RE: Comments on the Draft of Integrated Ecosystem Restoration and Hurricane Protection:
Louisiana's Comprehensive Master Plan for a Sustainable Coast

Comments on the Draft of Integrated Ecosystem Restoration and Hurricane Protection: Louisiana's Comprehensive Master Plan for a Sustainable Coast

Submitted by the
Multiple Lines of Defense Assessment Team

Figure 5: The Morganza to the Gulf Levee alignment on 2005 CIR imagery. Note the thin and fragmented marsh is all that separates the levee from Terrebonne Bay. Also note the inclusion of wetland areas within the alignment.

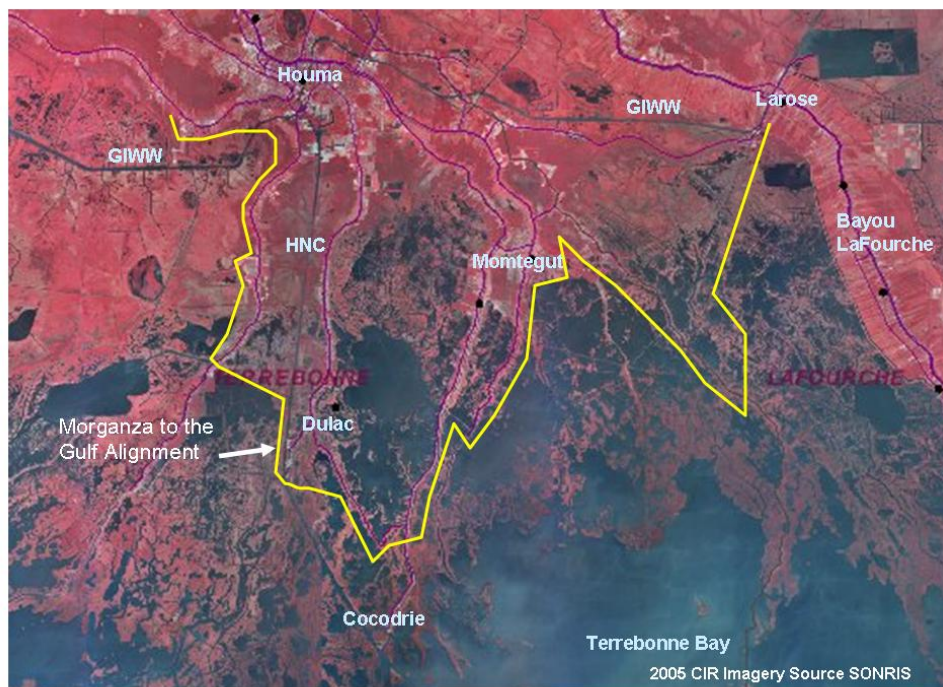
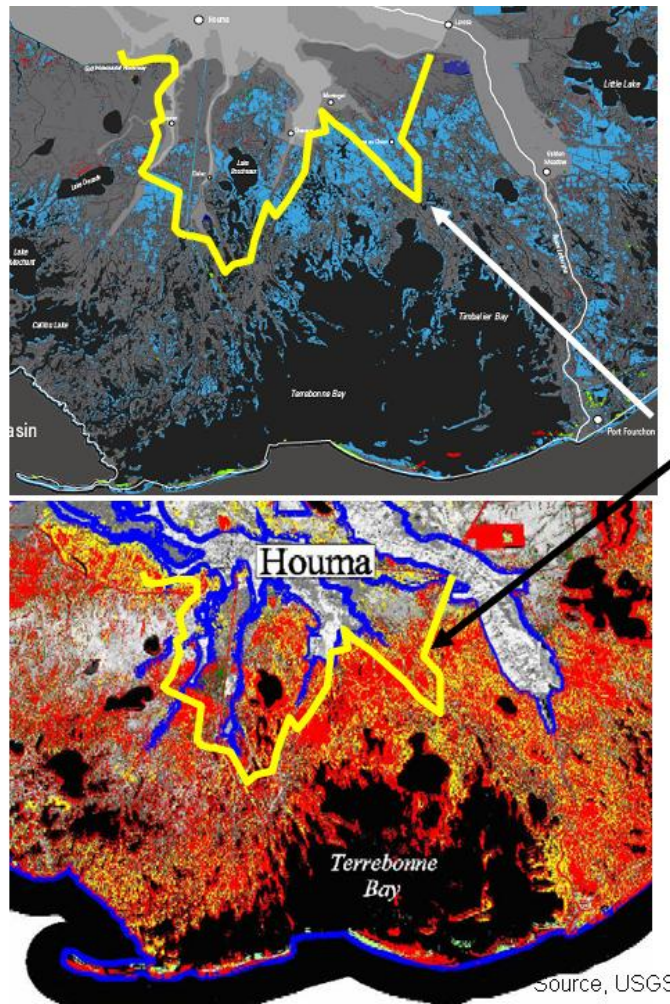
Assessment Team Comment: It is inappropriate considering the aftermath of Hurricanes Katrina and Rita including the lessons-learned, the federal financial limitations, and the specter of greater storm surge threats that the Morganza to the Gulf project is effectively “grandfathered” into the state's master plan. Those that might think the hurricanes are de facto proof of the need for Morganza to the Gulf misunderstand the lessons the storms provide. In New Orleans, it was an inadequate flood protection system that resulted in the disastrous consequences of Hurricane Katrina. The recent Team Louisiana report issued by the La DOTD makes this abundantly clear. The Morganza to the Gulf was conceived in another time when less surge and more coastal restoration was anticipated. To the contrary restoration has not been adequate and greater storm surge due to more frequent higher category hurricanes is now anticipated. **Figures 5 and 6** dramatically illustrate the proximity of the alignment to the Gulf, the adjacent historic land loss and the calamitous potential of future land loss. Morganza to the Gulf places a regional levee alignment too far south impounding wetlands and reducing the storage for storm surge. The alignment forebodes a new false security for the region that may well lead to future disastrous consequences. The tax payers who might pay for this project and the residents who might chose to live within this levee alignment deserve more than an outdated and ineffective flood protection system design.

The Assessment Team recommends an alternative be evaluated using ring levees (segmented back levees) on each of the individual ridges (see Figures 2 and 3). This is consistent with the ridge/ estuary model. This approach in combination with non-structural approaches may actually provide a higher and more reliable flood protection level.

Figure 7: Proposed East Atchafalaya River Spillway that could be used to restore the west side of Planning Unit 3 a (Kemp and Hyfield, 2005)

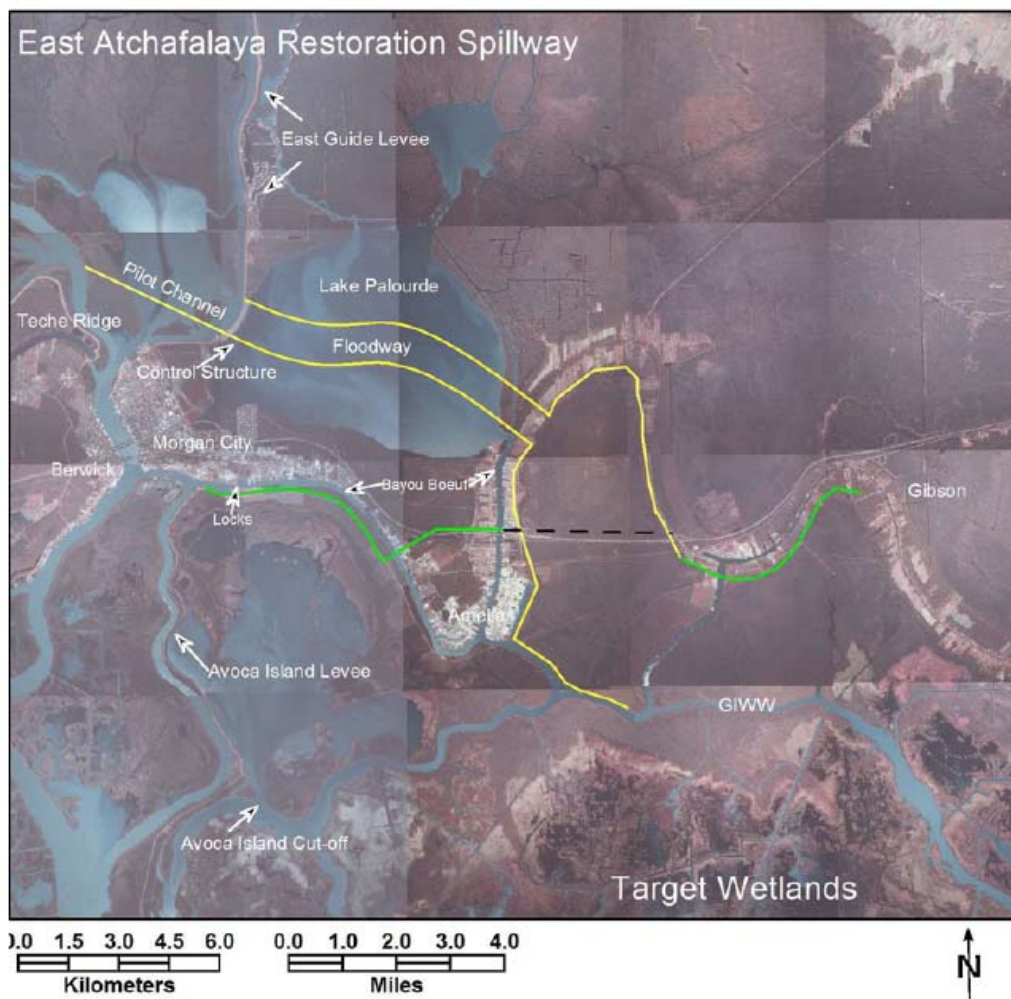
The proposal to construct a spillway just upstream of Morgan City should be included as an alternative in the state master plan. A proposal referred to as “East Atchafalaya River Spillway” (EARS) was proposed by Dr. Paul Kemp (Figure 7) in a report to Environmental Defense (Kemp & Hyfield, 2006). This proposal is strongly consistent with the Multiple Lines of Defense approach since it emphasizes restoration into an area that can provide as a surge buffer. The project has great potential for long term sustainability of the Penchant Basin and the eastern areas of the Planning Unit 3 a (west of Terrebonne Bay. In light of the post-Katrina strategy to accelerate and maximize coastal restoration the original proposal should be evaluated to higher discharges than originally proposed. It is conceivable that the best alternative a near complete river diversion through a spillway which captures the majority of discharge through the Atchafalaya Delta.
